**FINDINGS AND RECOMMENDATION  
OFFICE OF PLANNING AND ZONING  
ANNE ARUNDEL COUNTY, MARYLAND**

**CASE NUMBER:** 2024-0215-V

**REQUEST**

The applicant is requesting a variance to allow a dwelling and associated facilities with less setbacks than required and with disturbance to slopes of 15% or greater on property located at 779 Snodgrass Road in Crownsville.

SEPTIC PLAN  
LOTS 22 & 23 HERALD HARBOR  
TAX MAP 31 BLOCK 23, PARCEL 390  
ZONED R5  
SECOND DISTRICT  
ANNE ARUNDEL COUNTY, MD 21032  
JOB# 20-257

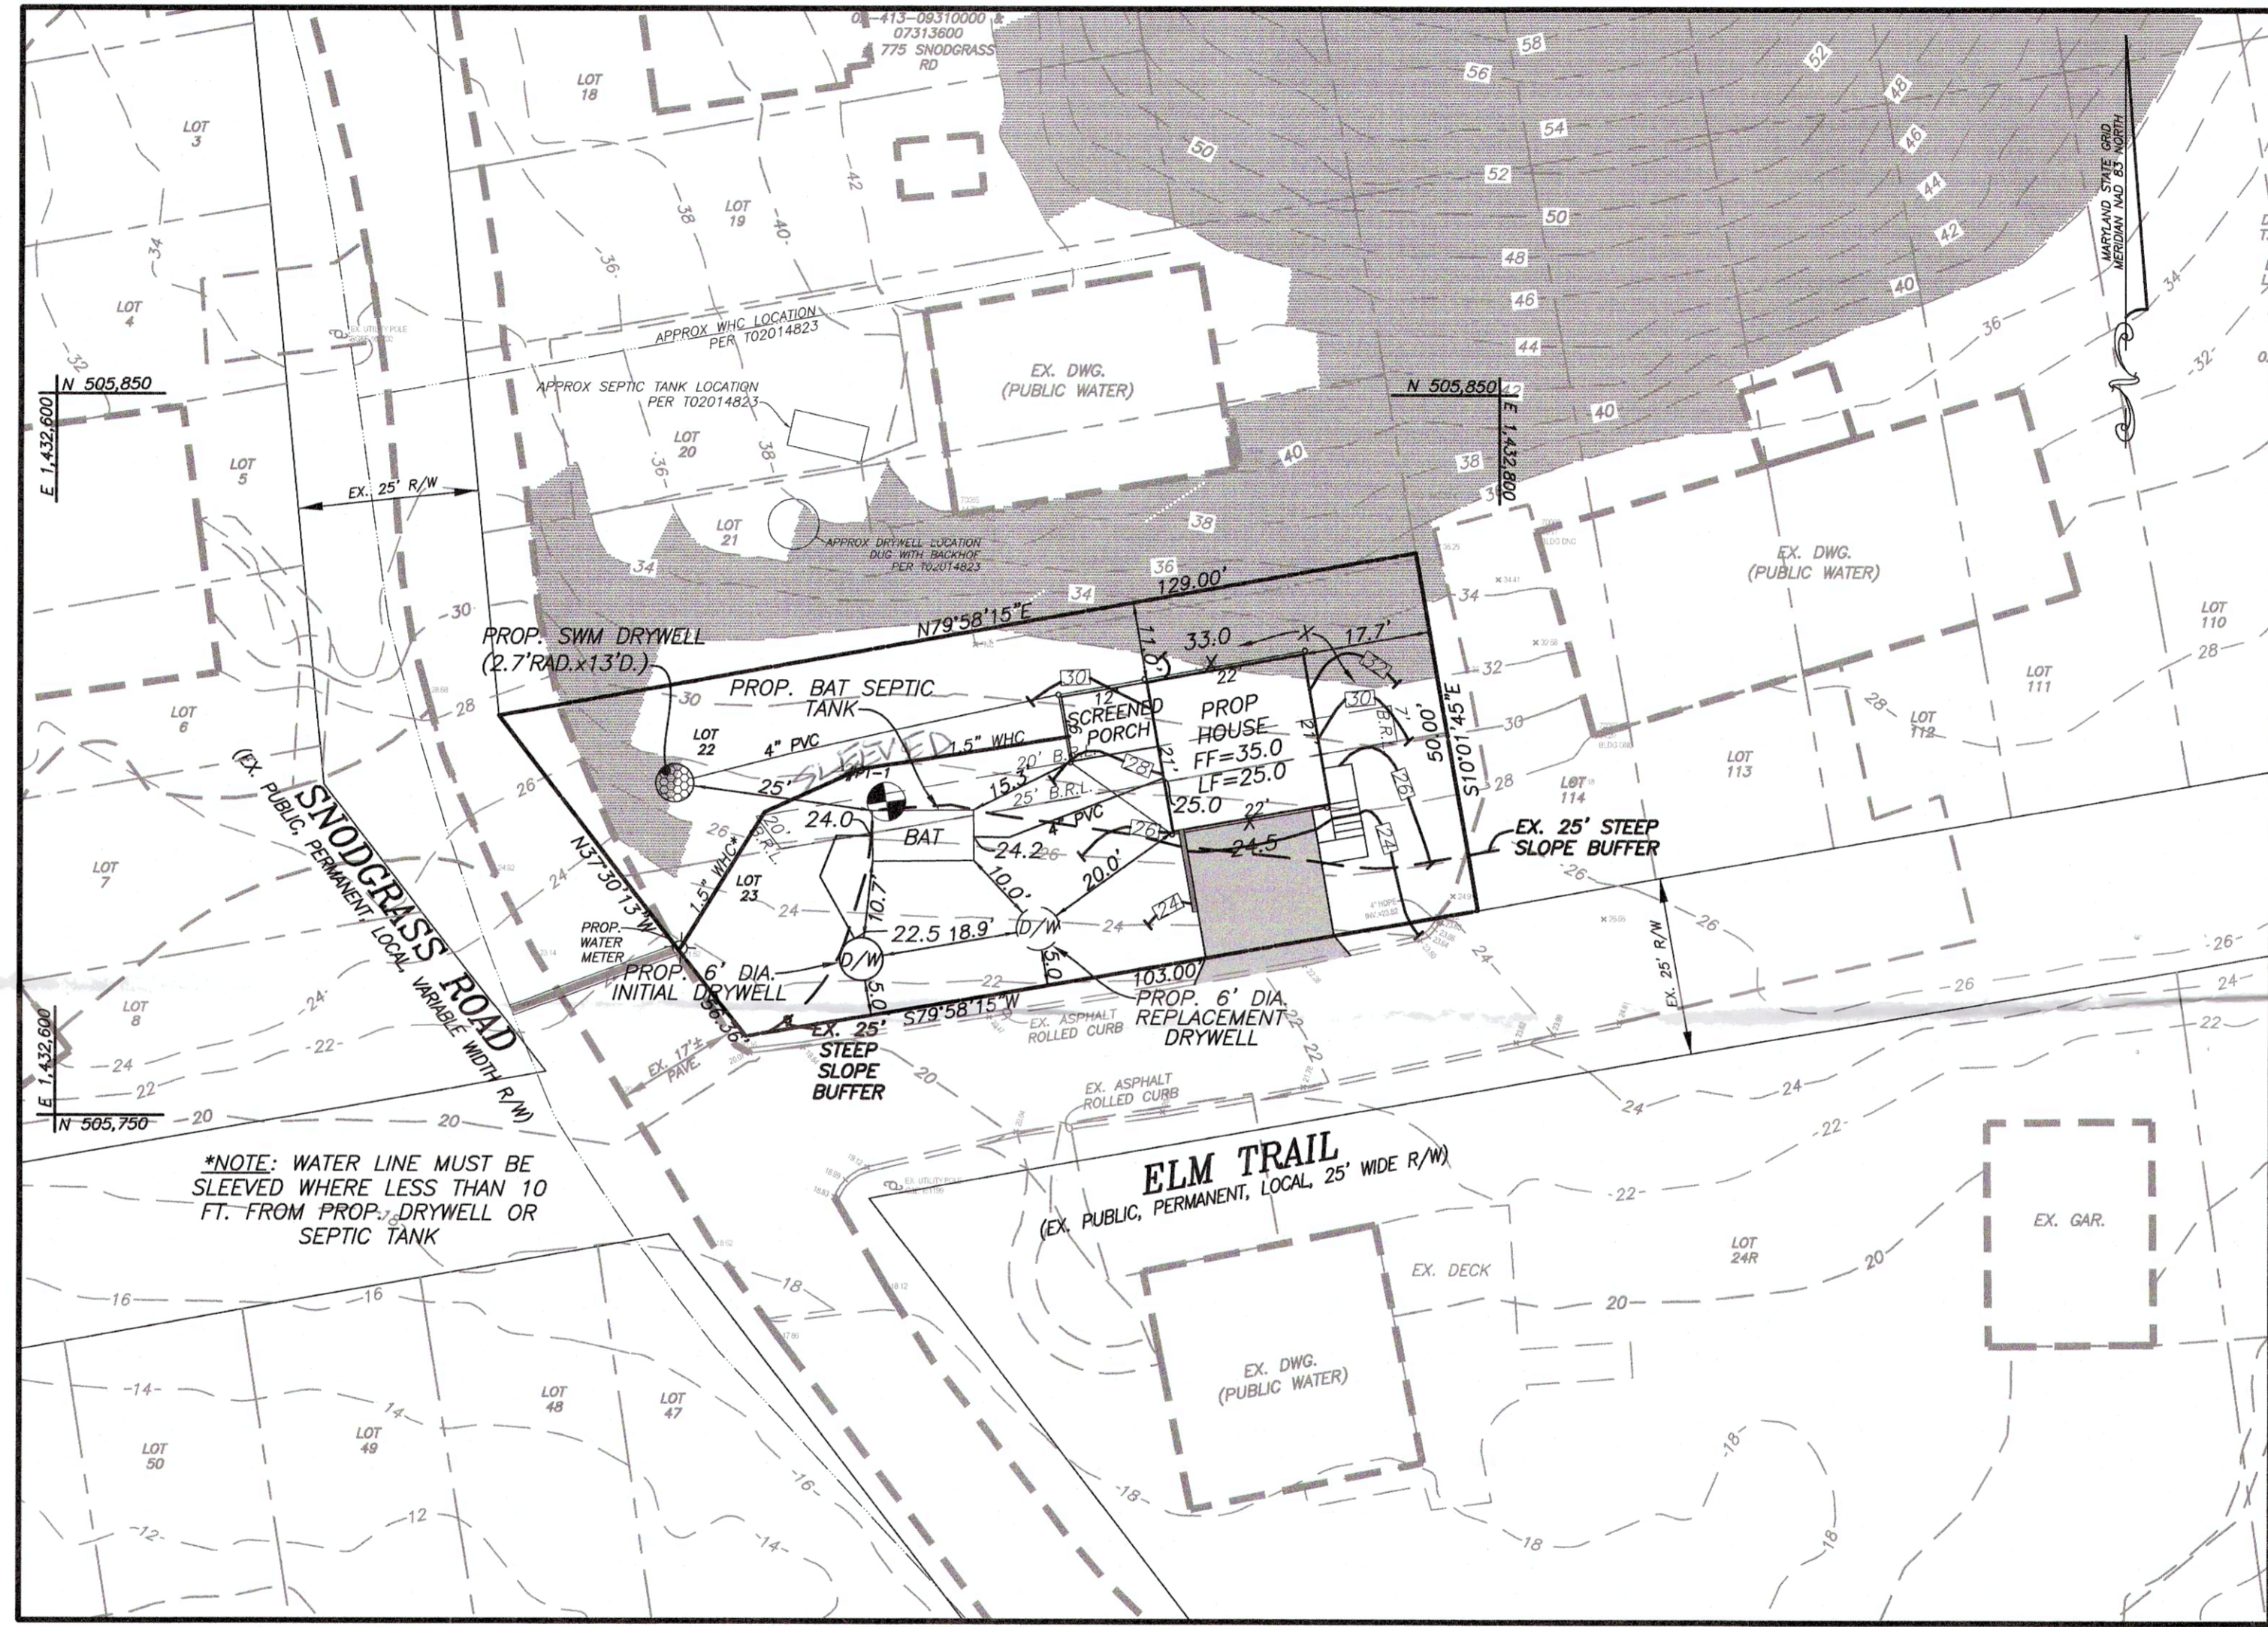
14. Please note, it appears the Septic Site Plan will need to be revised, as there are issues with the area quantities in the Building Permit Site Data Chart shown on the plan (Prop. Cover (Bldg.) and prop. Cover (Impervious)). The SWM Drywell is also labeled as a different size.
